**METROPOLITAN GOVERNMENT OF NASHVILLE AND DAVIDSON COUNTY**

**STAFF RECOMMENDATION**  
**1121 5<sup>th</sup> Avenue North (515 Madison St)**  
**August 18, 2021**

**Application:** Signage

**District:** Germantown Historic Preservation Zoning Overlay

# CHANNEL LETTER CAPS FOR EXISTING LETTER SET

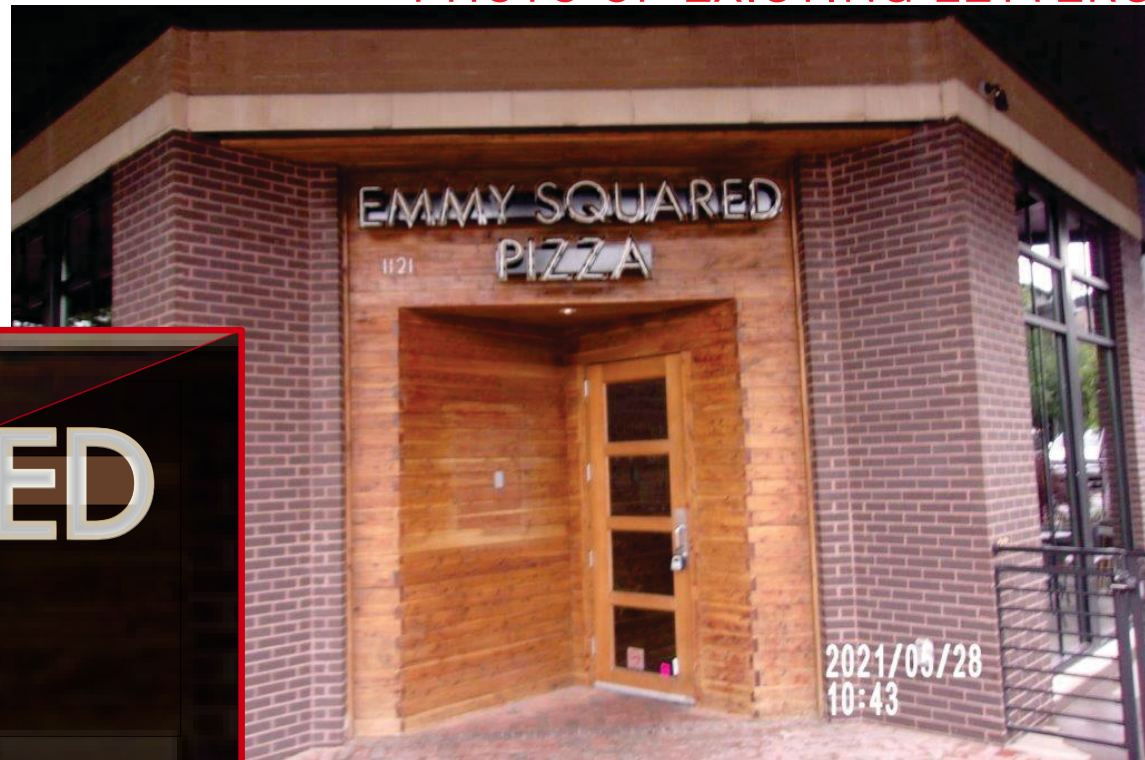
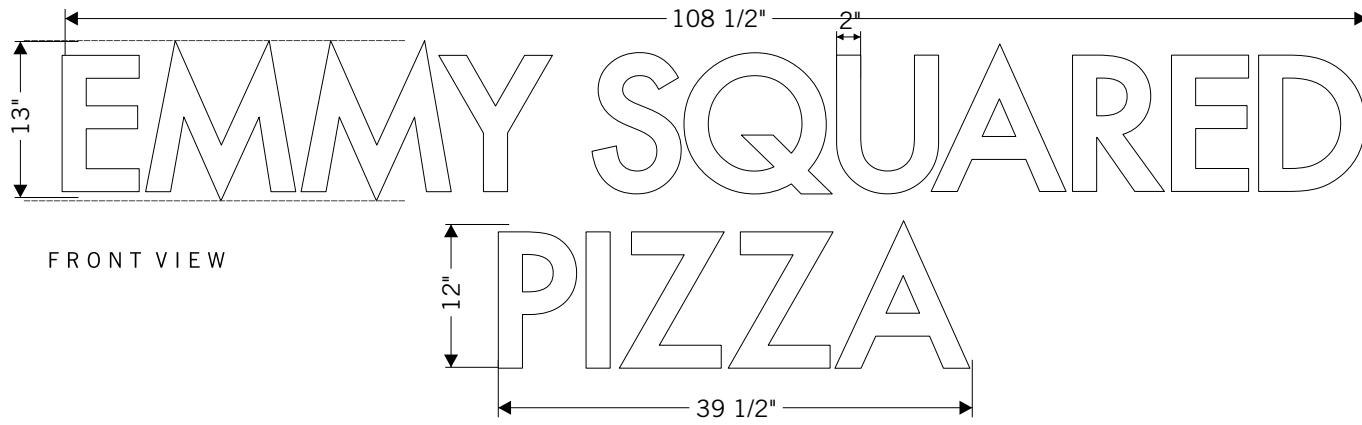
The applicant now proposes to retain the sign and place over each letter a clear polycarbonate face with a frosted film. Section VI (4) (d) of the design guidelines states that, *For cabinet signs, the background must be opaque. Only text may be illuminated, and a halo of one inch around text logos may be non-opaque.* In the proposed scenario, there would not be one large cabinet with an opaque background as each letter is a channel letter. Staff finds this solution to be less intrusive than creating a cabinet around the entirety of the sign and to meet the requirements. Since the neon illumination would be covered with the frosted plastic, the solution meets Section VI (4) (e) as the neon would no longer be “exposed” and just serve as an internal light source.

**Recommendation:** Staff recommends approval of the addition of frosted polycarbonate caps over the existing channel letters for the sign at 515 Madison; finding that the project meets section VI of the design guidelines for signage in the Jefferson Street subdistrict of the Germantown Historic Preservation Zoning Overlay.
